Sheet No. C0.0

Project Title:
EAST TOWN CROSSING PHASE 1

Project No.
2230752
Issue Set & Date:
PERMIT SUBMITTAL
11/20/2023

Sheet No.
C5.03
47 of 63 Sheets

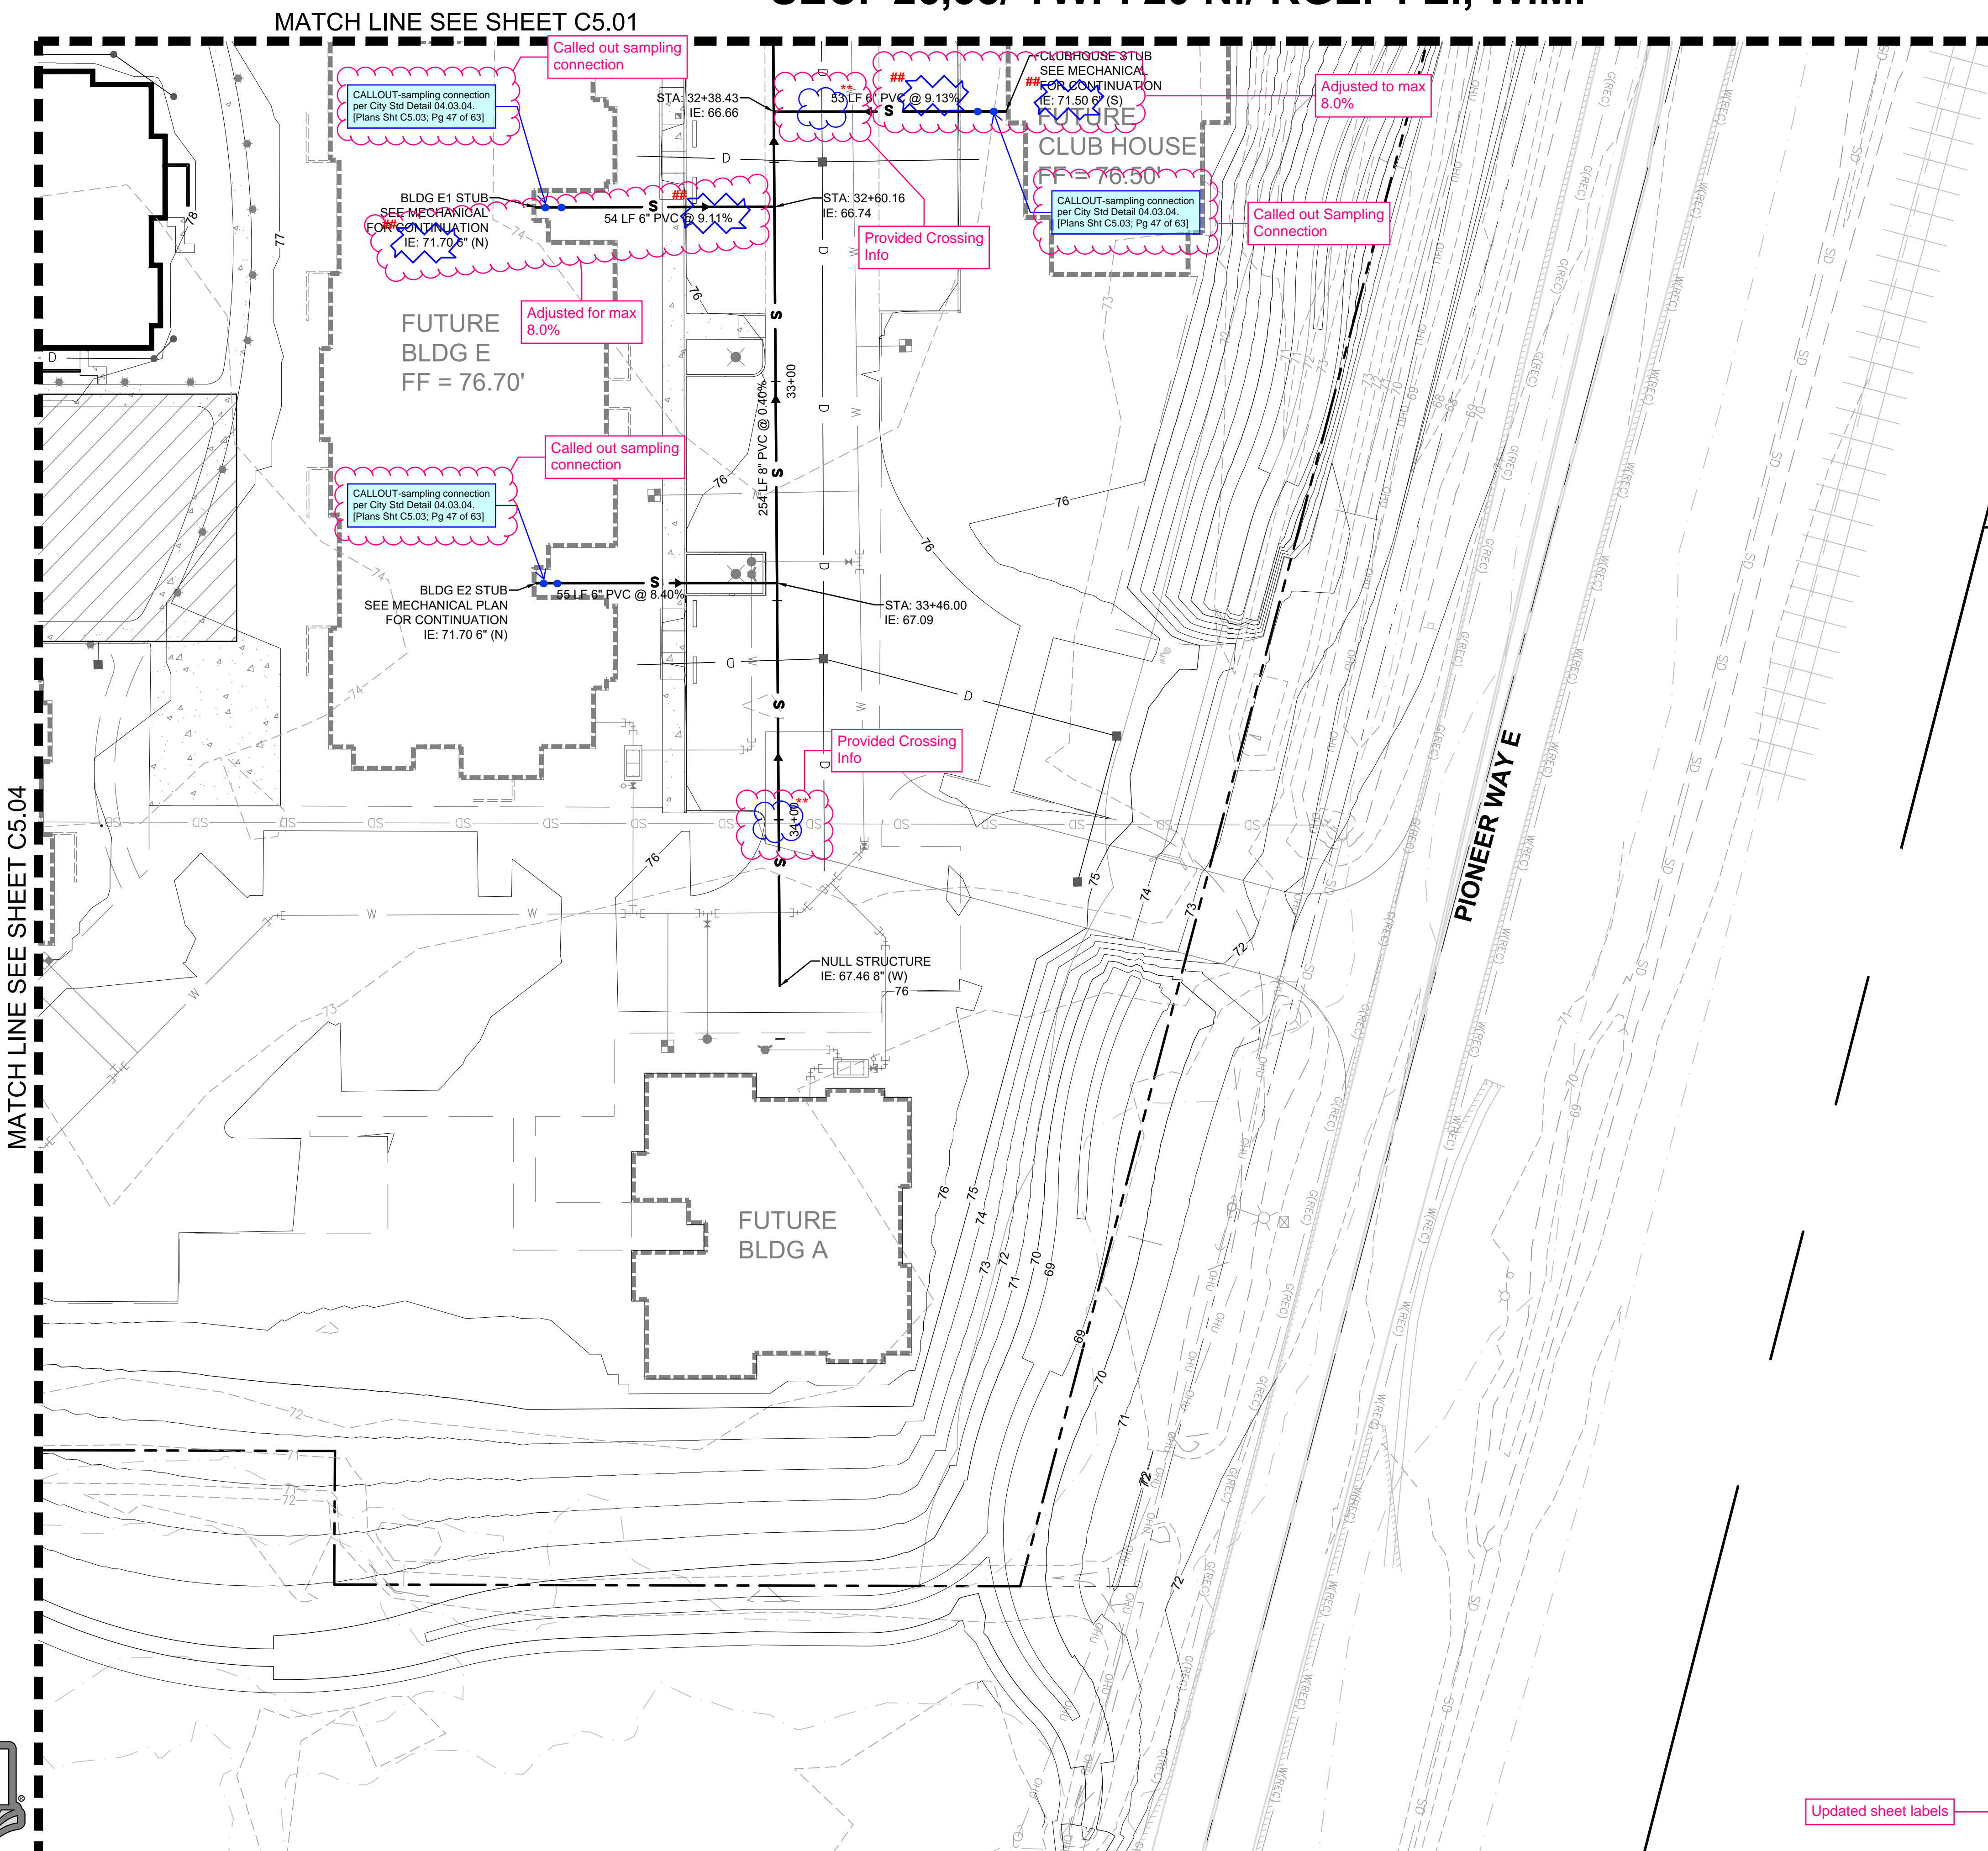
Service lateral exceeds max. grade (8% max). Revise accordingly. [Plans Sht C5.03, Pg 47 of 63]

Provide utility crossing information. [Plans Sht C5.03, Pg 47 of 63]

Sheet No.
C5.05
49 of 63 Sheets

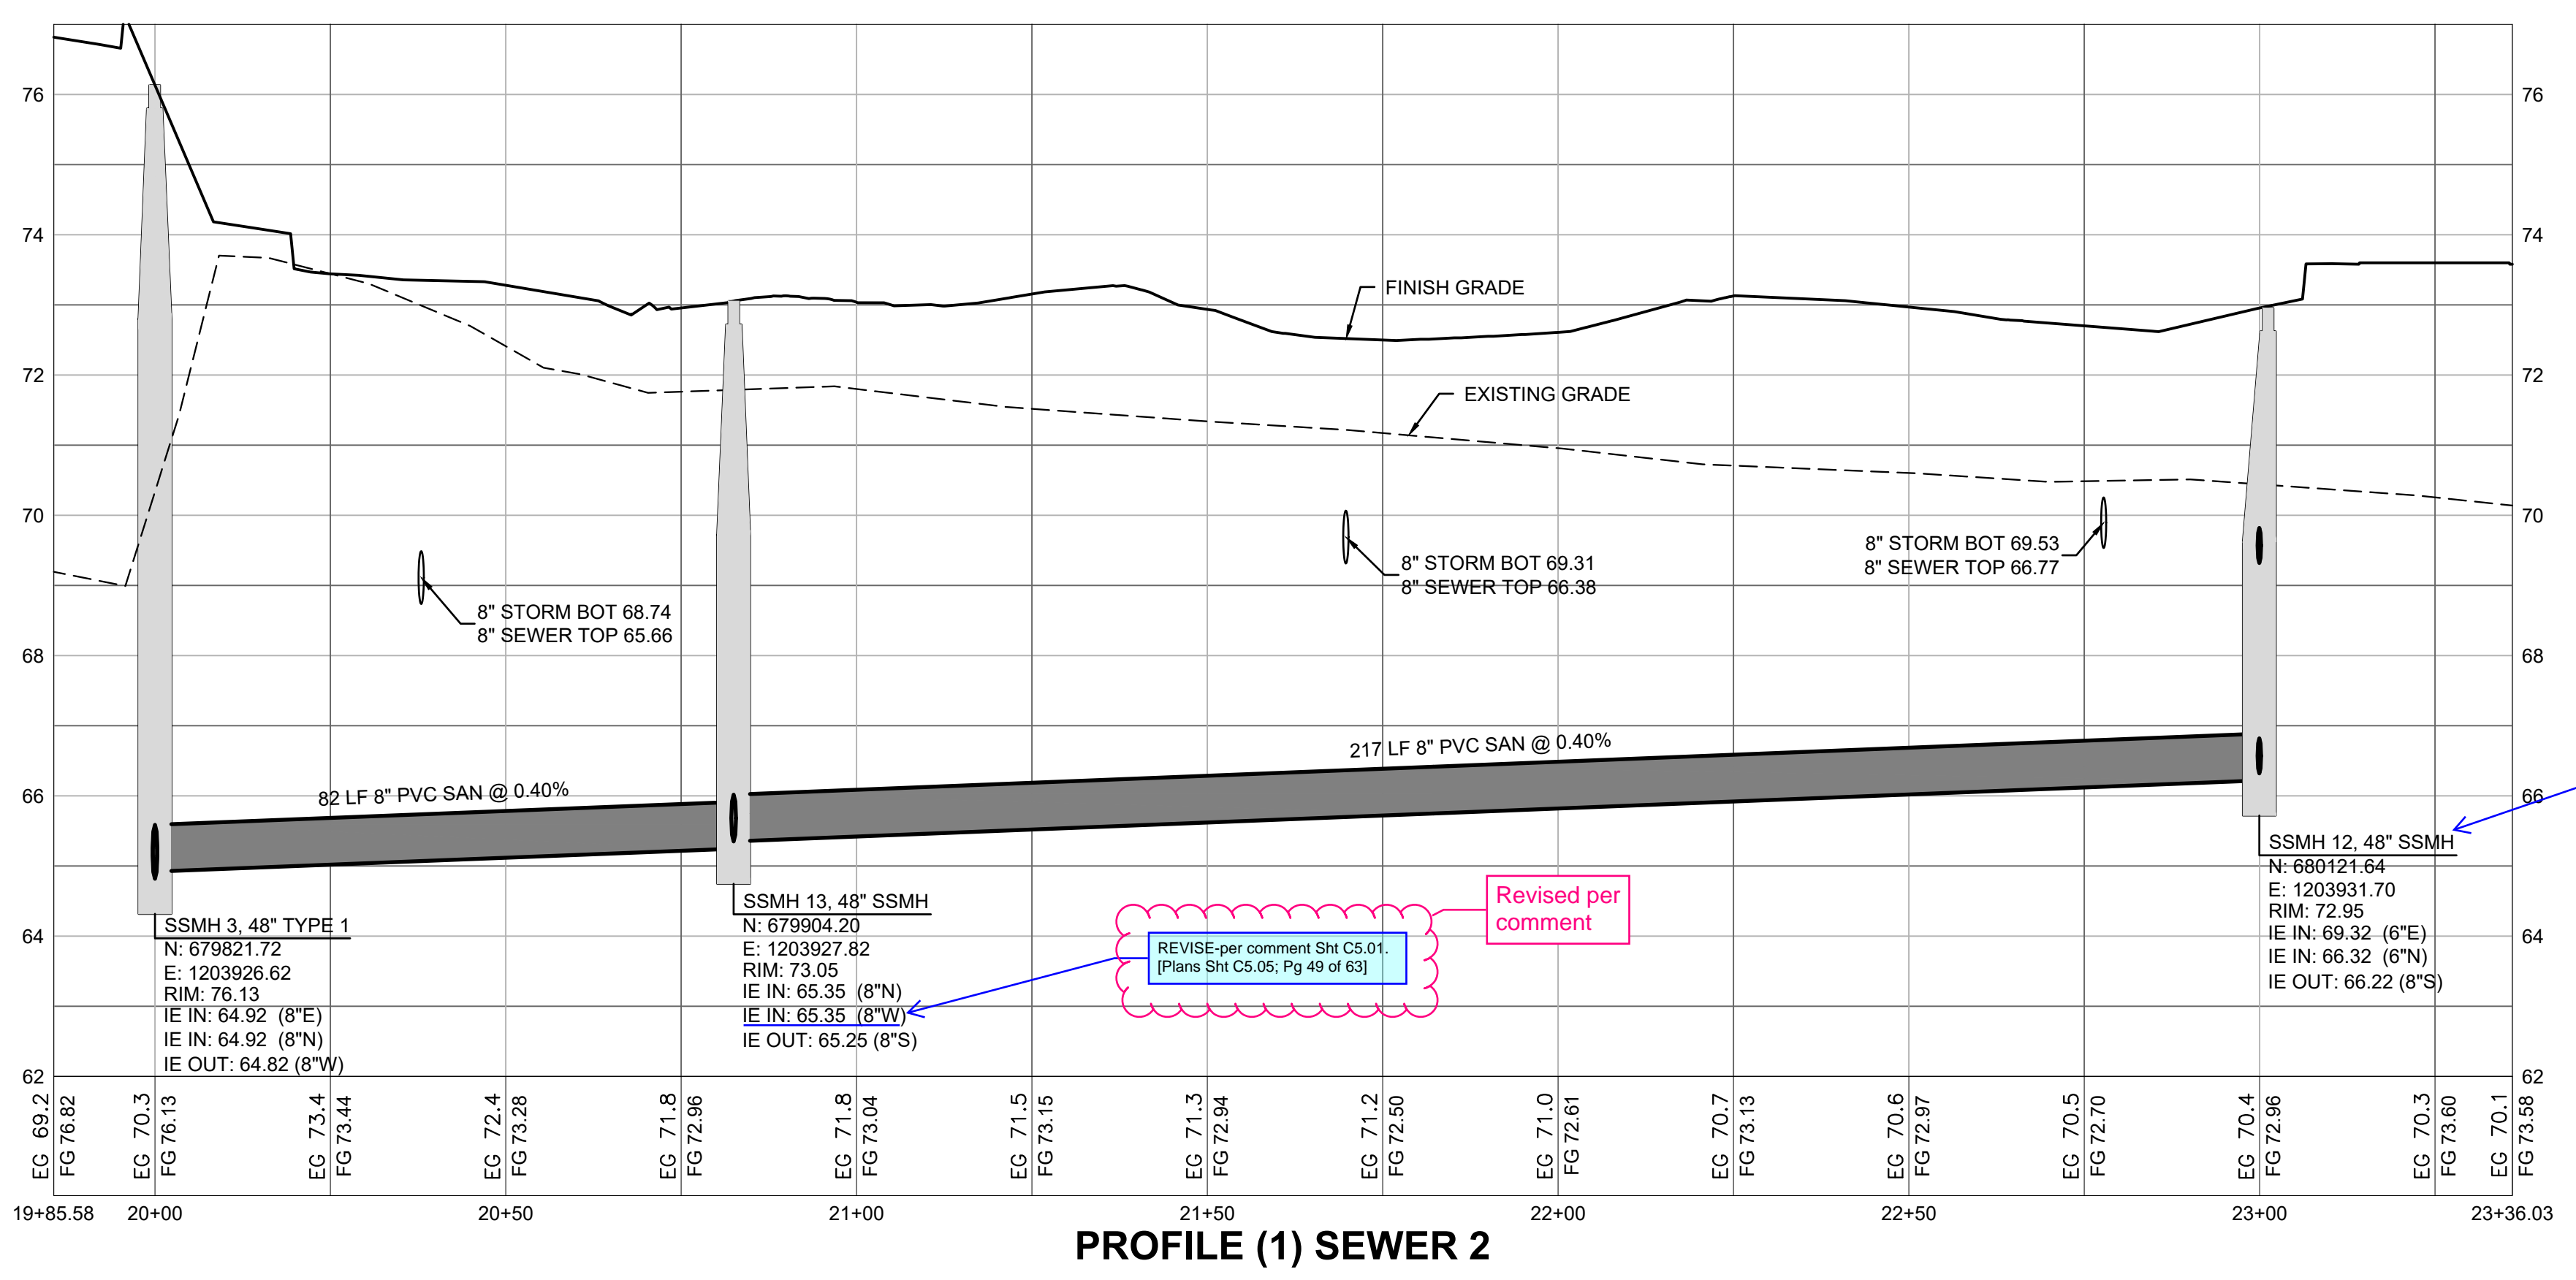
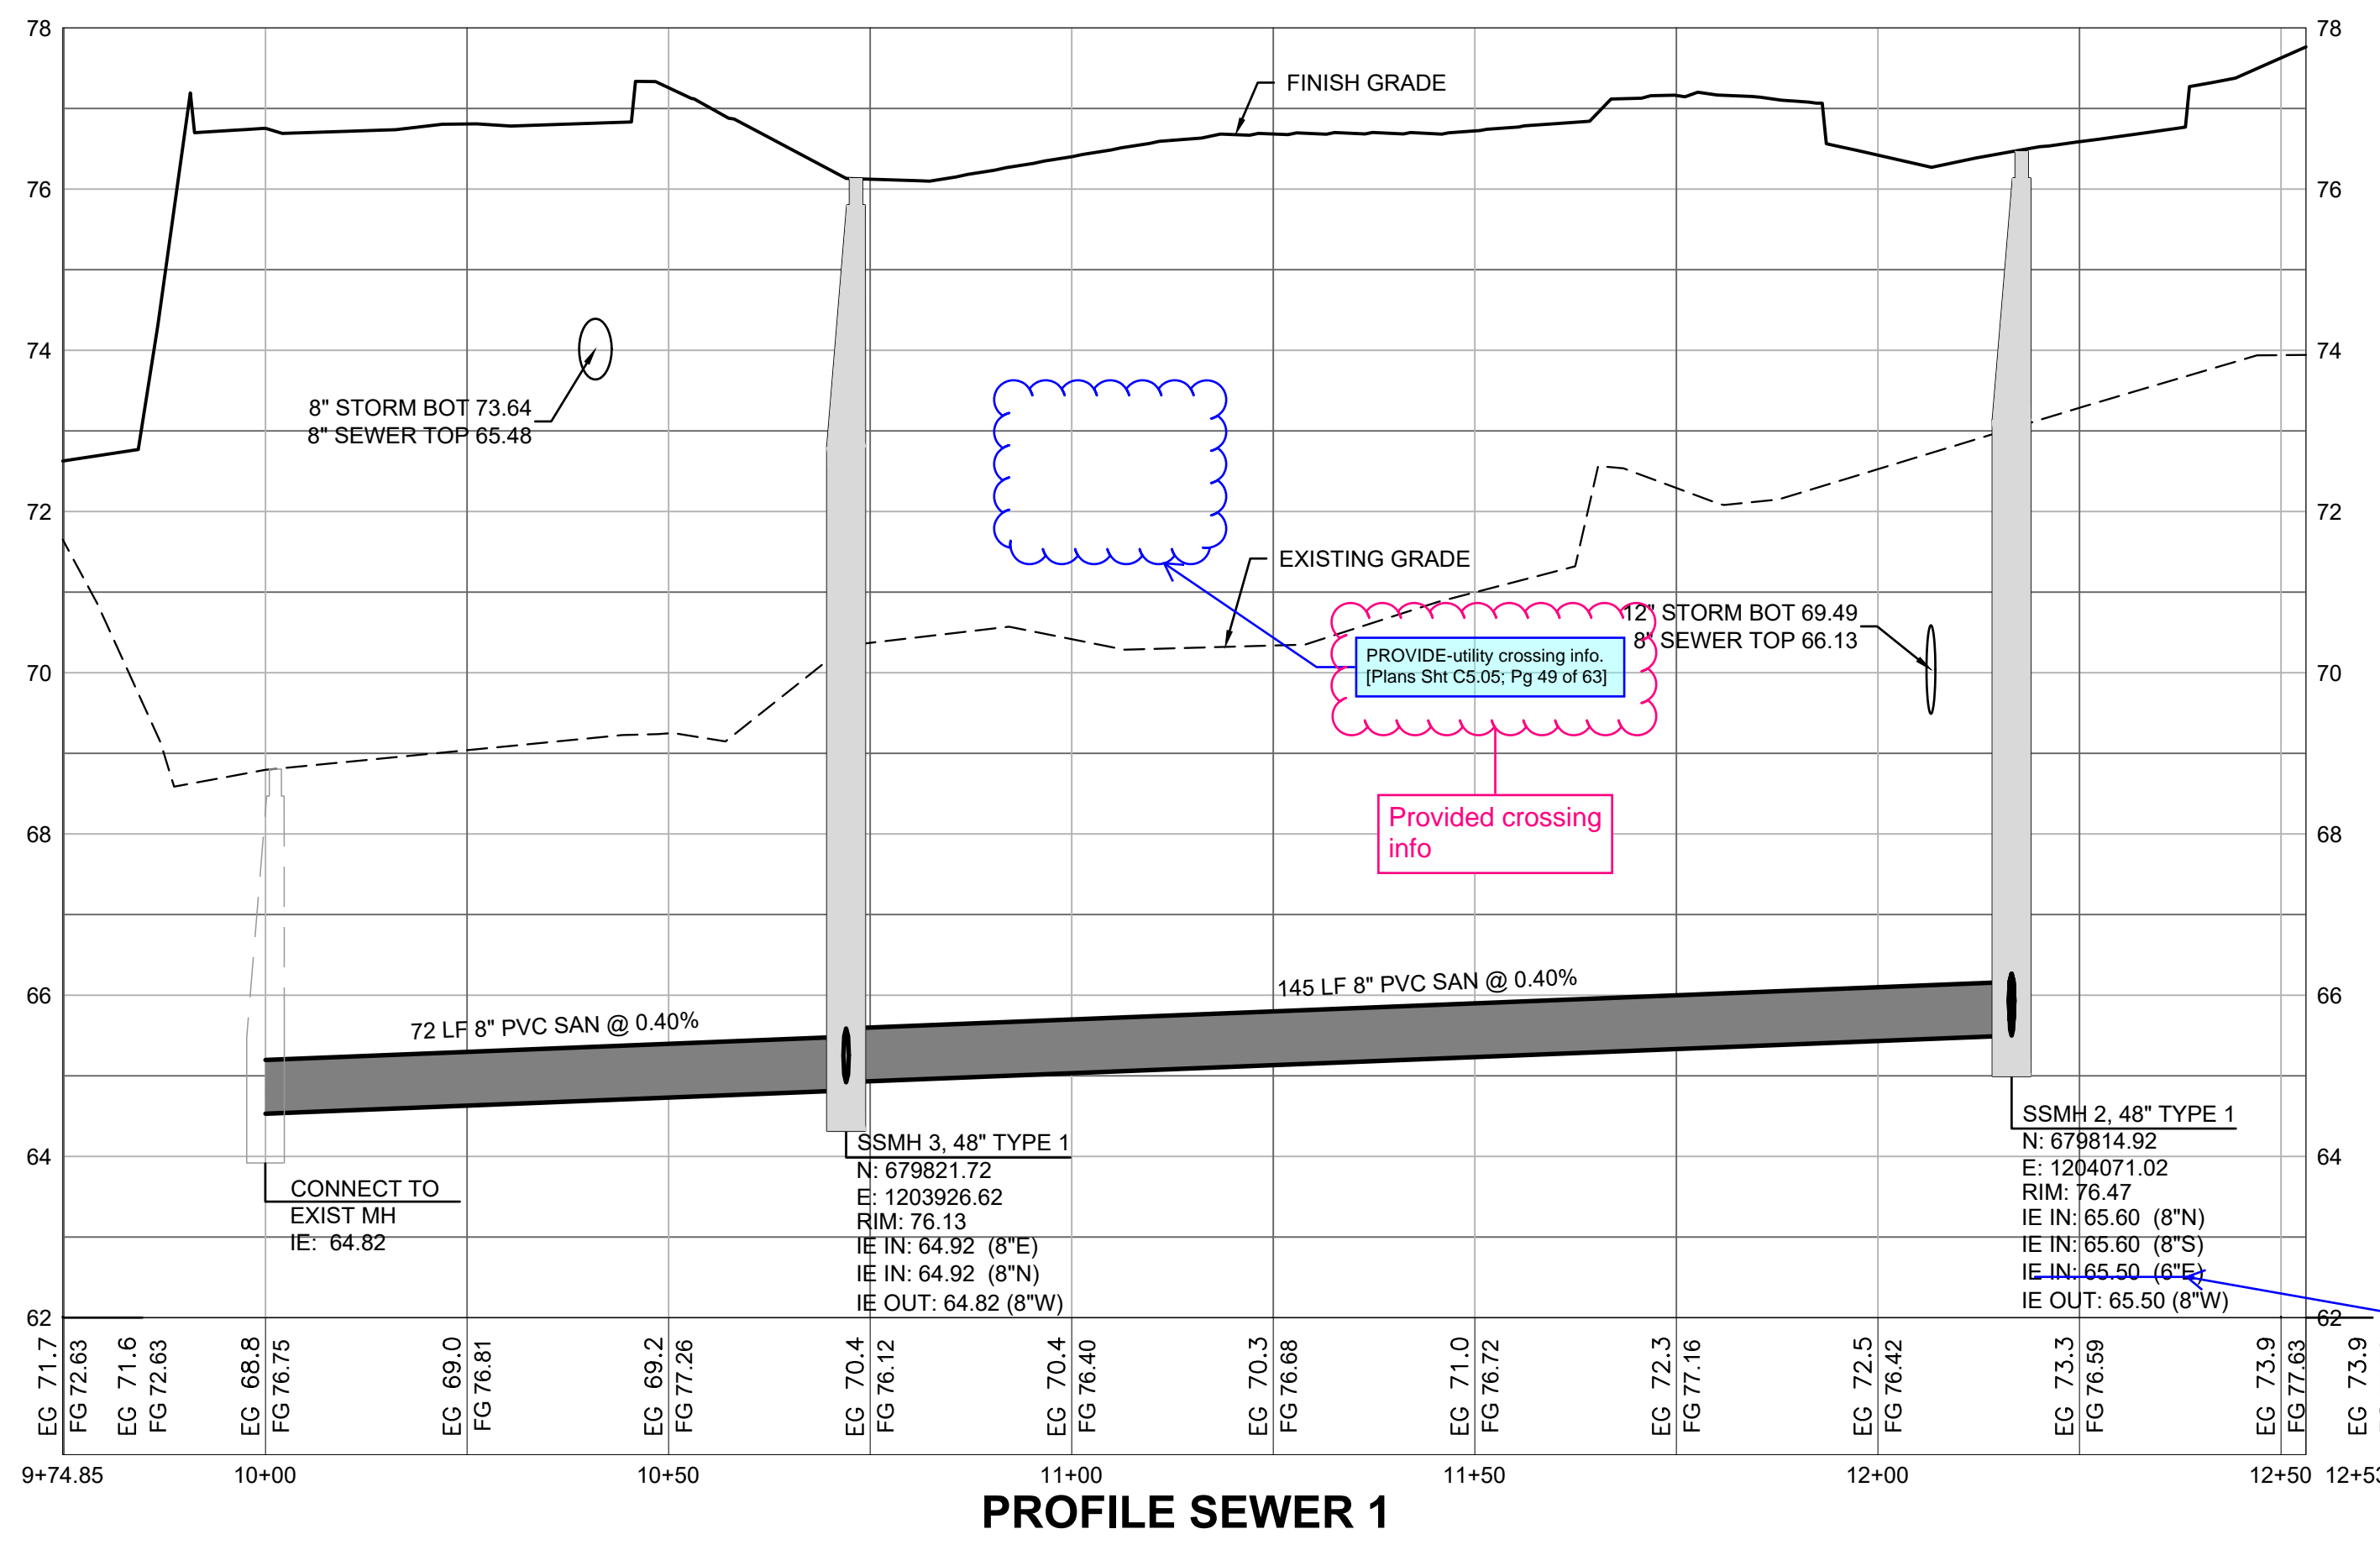
REVISE-per comment Sht C5.02. [Plans Sht C5.05; Pg 49 of 63]

CALLOUT-drop manhole per City Sht Detail 04.01.02 [Plans Sht C5.05; Pg 49 of 63]
